File: NG-3514

Serial: NG-73-410

H. B. ROBINSON UNIT NO. 2
LICENSE DPR-23
IRRADIATION SURVEILLANCE PROGRAM

Revisions Required to Technical Specifications

FIGURE 3.1-1

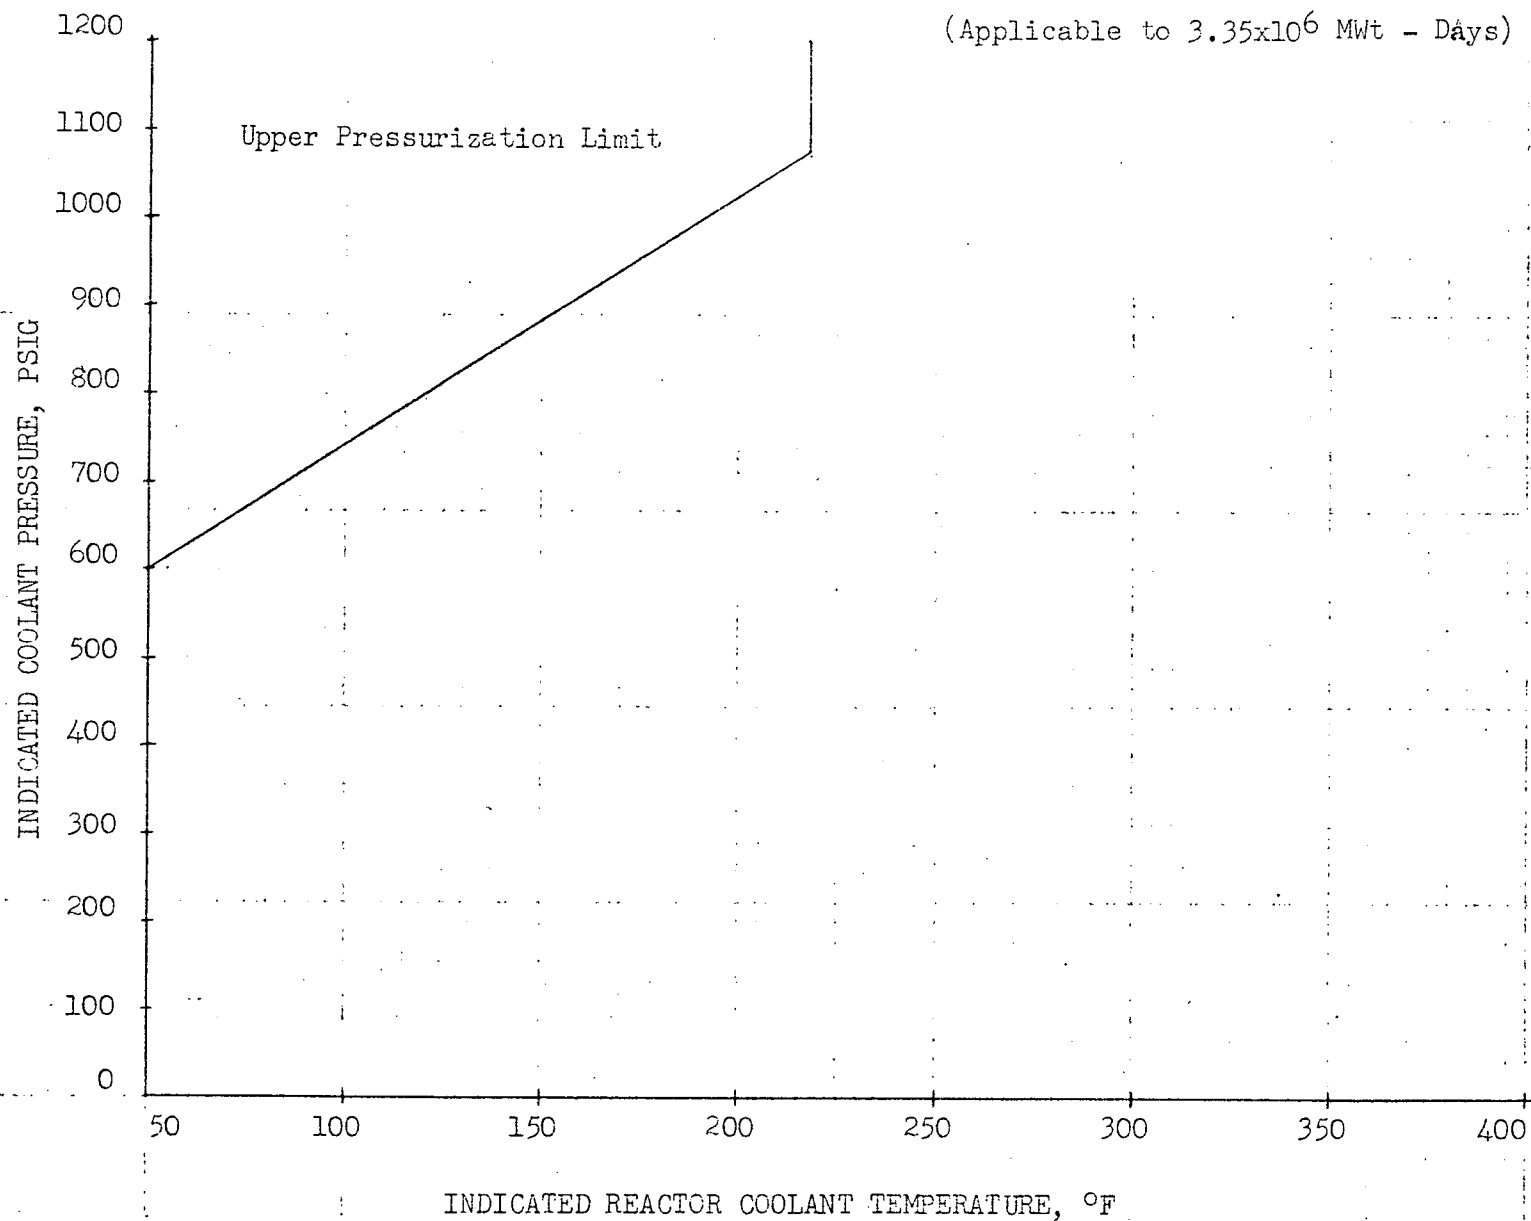
As a result of the data obtained from the capsule, various changes are required to update the plant Technical Specifications to reflect the projected neutron fluence and NDTT shift for the forthcoming surveillance interval.

The next specimen is to be removed after the fifth year of operation. This corresponds to 3.35×10^6 thermal megawatt days (≈ 1523 EFPD). The predicted neutron fast flux for this period is 4.57×10^{18} neutrons/cm² > 1 MeV. Using this value in conjunction with Figure 3.1-3 of the Technical Specifications yields an NDTT shift of 117°F. This figure is then used to arrive at a design transition temperature (DTT) to establish revised limit lines for Figures 3.1-1 and 3.1-2 of the Technical Specifications. The subject figures relate to system heatup and cooldown rates. The DTT obtained in this manner is 208°F and DTT +10°F is 218°F. The attached Figures 3.1-1 and 3.1-2 have been revised to reflect this shift. Also attached are revised pages to Section 3.1.2 of the Technical Specifications which incorporate the preceding changes.

For heatup, the thermal stress is reversed and the location of the limiting stress is a function of the heatup rate. The limit lines no longer bear the simple relationship to heatup as they do to cooldown rate. The single line shown on Figure 3.1-1 bounds all limit lines for heatup rates up to 40°F per hour for temperatures at or below 140°F, and 100°F per hour above 140°F.

REACTOR COOLANT SYSTEM
HEATUP LIMITATIONS

(Applicable to 3.35×10^6 Mwt - Days)

FIGURE 3.1-2

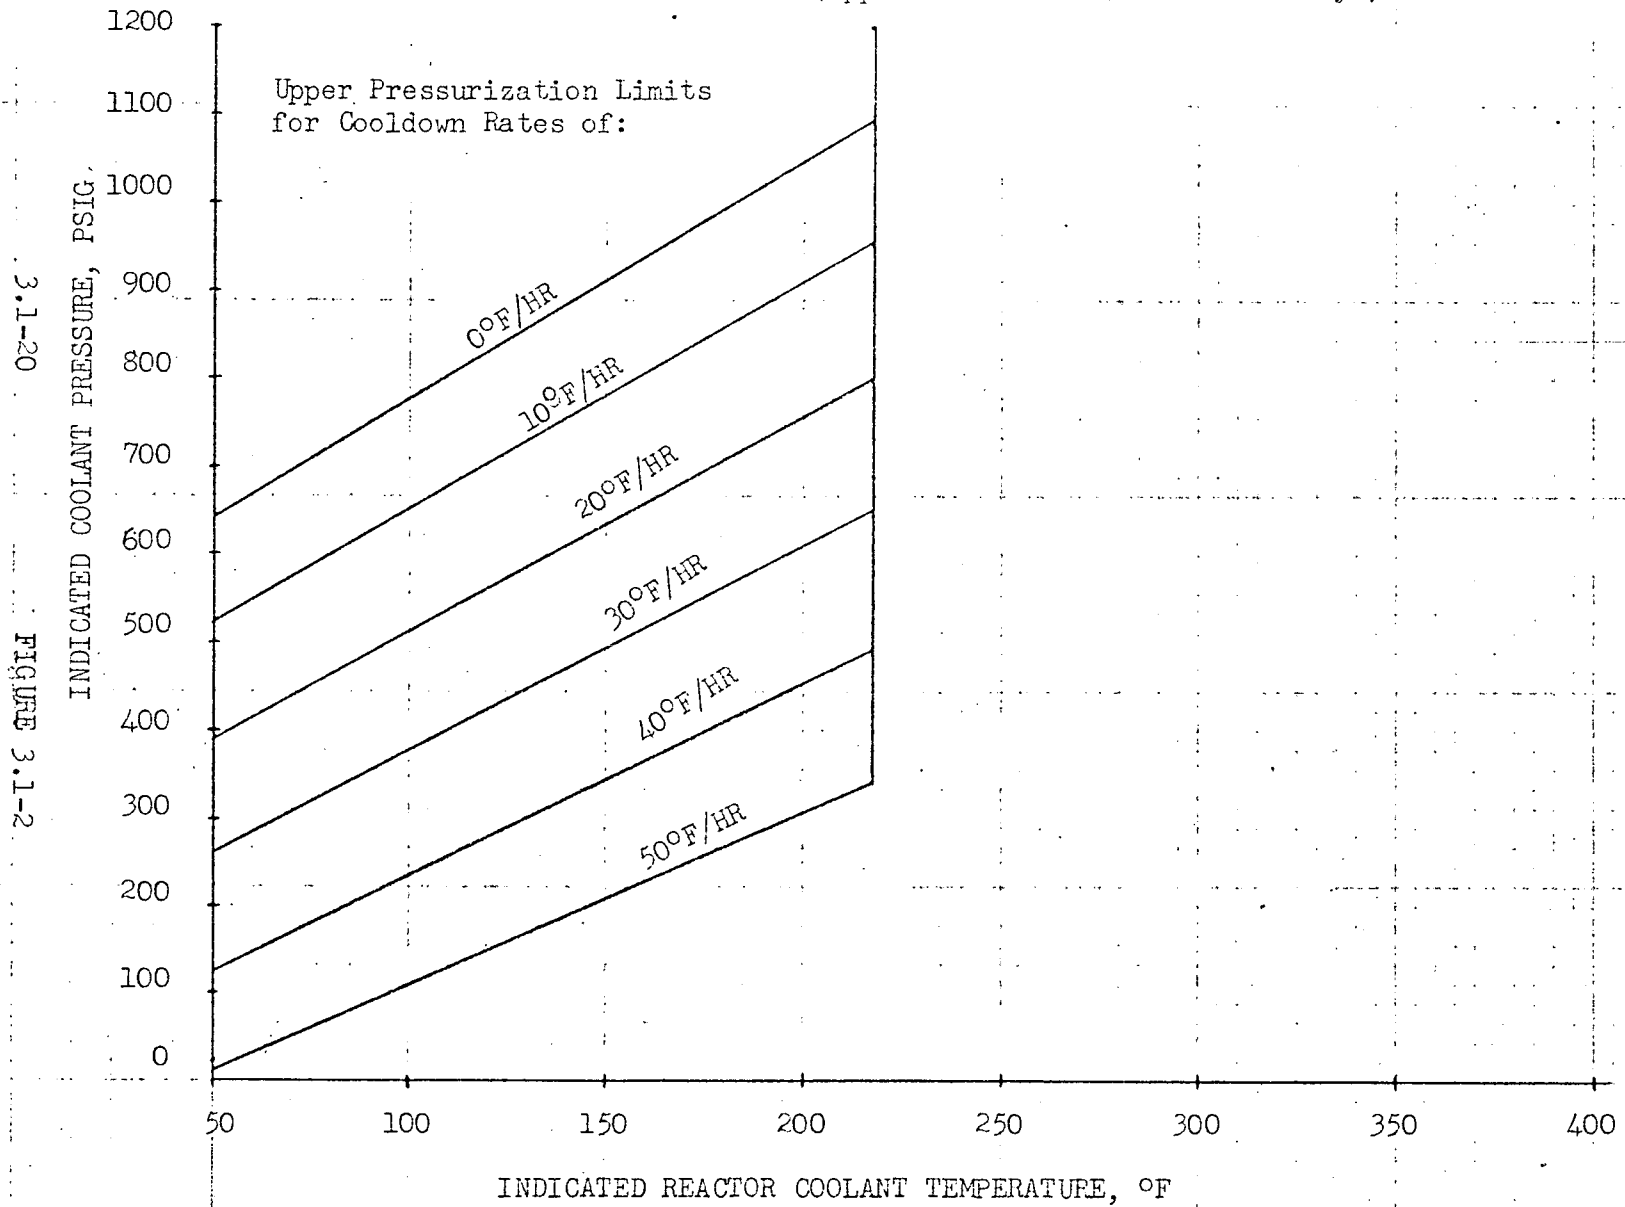
During cooldown, the thermal stress varies from tensile at the inner wall to compressive at the outer wall. The internal pressure superimposes a tensile stress on this thermal stress pattern, increasing the stress at the inside wall and relieving the stress at the outside wall. Therefore the limiting stress always appears at the inside wall, so the limit line has a direct dependence on cooldown rate. This leads to a family of curves for cooldown, as shown on Figure 3.1-2.

REACTOR COOLANT SYSTEM
COOLDOWN LIMITATIONS

(Applicable to 3.35×10^6 Mwt - Days)
